SRC4182 is muted at no input from input source because MUTE pin tied to RDY pin. In this condition, DC level is output from SDOUT and it can cause noise.

With input data

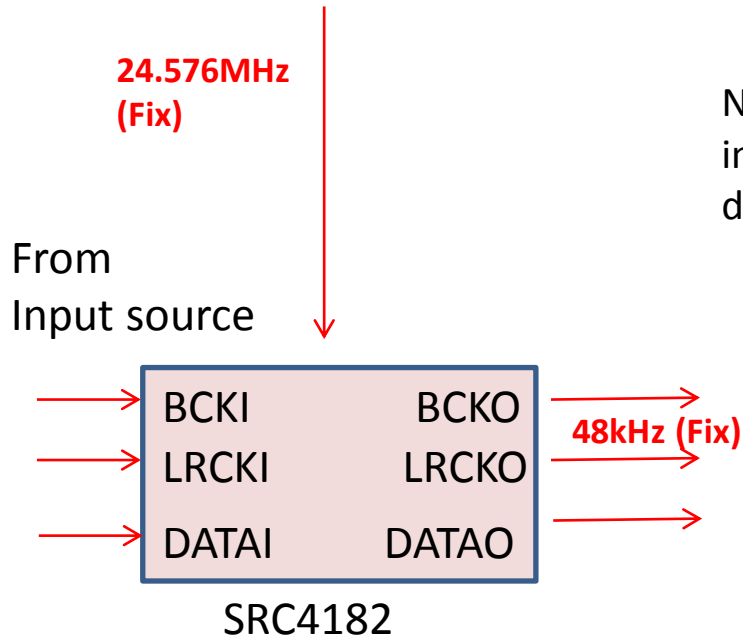
- 1, Is it normal operation the DC level is output from SDOUT at mute condition?
 - 2, Do you have the way to shut off this DC level output?
 - 3, Can they know what voltage is output from SDOUT if it's default operation?
- They are asking this because they confirmed various voltage at each checking.
